NOTIFICATION

#0002

SUBJECT: Wires overheating on Rotax 912 iS B-side voltage regulators

MODELS AFFECTED: All Sling LSA and Sling 2 aircraft fitted with Rotax 912 iS engines.

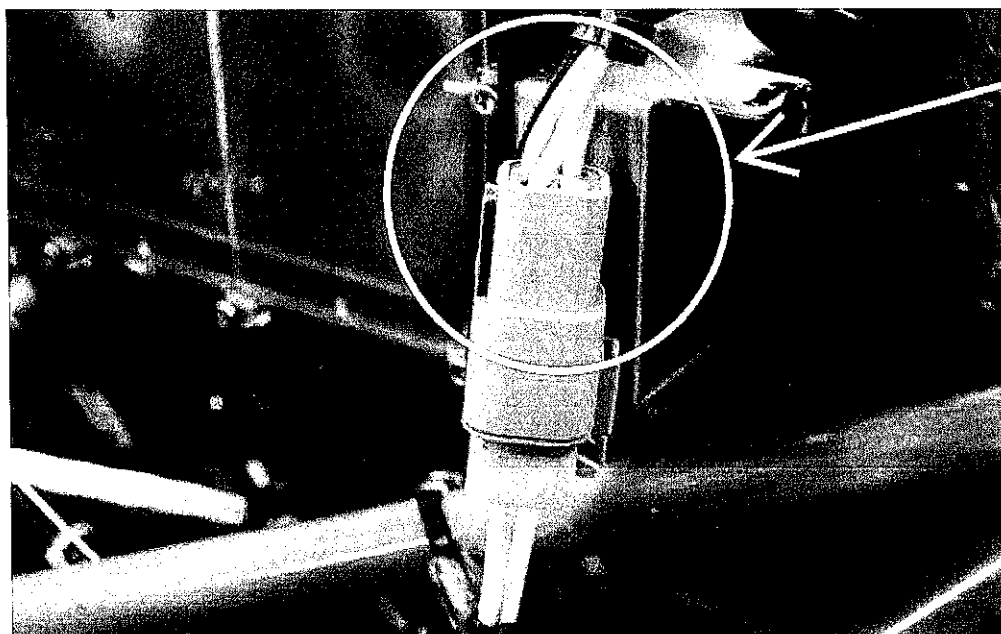
The B-side voltage regulator (which powers all auxiliary equipment such as instruments and lights) fitted to the Rotax 912 iS needs to have current drawn from it in order to remain cool. Should no current be drawn then the excess energy is dissipated through the wires and connectors which overheats them.

The A-side voltage regulator and wires remain cool because it has current drawn from it all the time to run the engine ignition system.

It is recommended that taxi, landing and strobe lights of Sling aircraft fitted with the Rotax 912 iS engine be kept in the "ON" position for the duration of all flights.

Before each flight the condition of the yellow wires running to the B-voltage regulator must be checked for discoloration. This can be done through the left-hand inspection door on the top engine cowling. (See attached photographs), with the exception of the following aircraft serial numbers:
